# PERMIT

SEWAGE DISPOSAL SYSTEM  
HOWARD COUNTY HEALTH DEPARTMENT  
BUREAU OF ENVIRONMENTAL HEALTH  
410-313-2640

P 514678

SUBDIVISION Wellington West II LOT NUMBER 21 ADDRESS 15305 Doe Hill Court

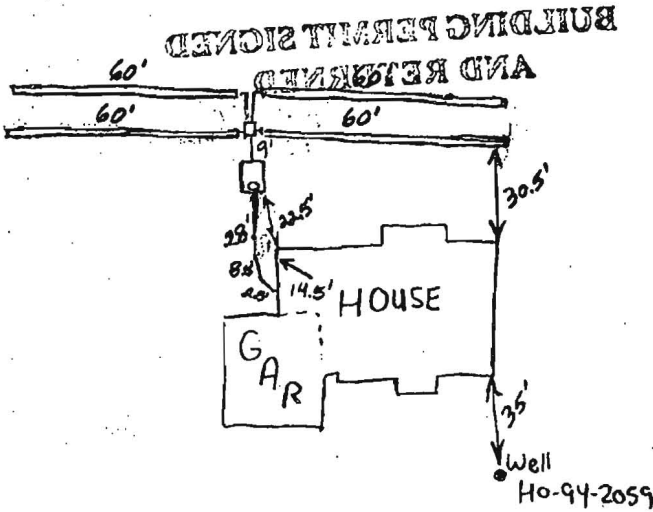
INSPECTION COMMENTS: 11/30/00-OK TO CONTINUE AND COVER MIDDLE OF TRENCHES, LEAVE ENDS OPEN, INSTRUCTED INSTALLER TO PLACE MANHOLE ON SEPTIC TANK (SRK)  
12/1/00 System satisfactory. O.K. to cover. (BB)
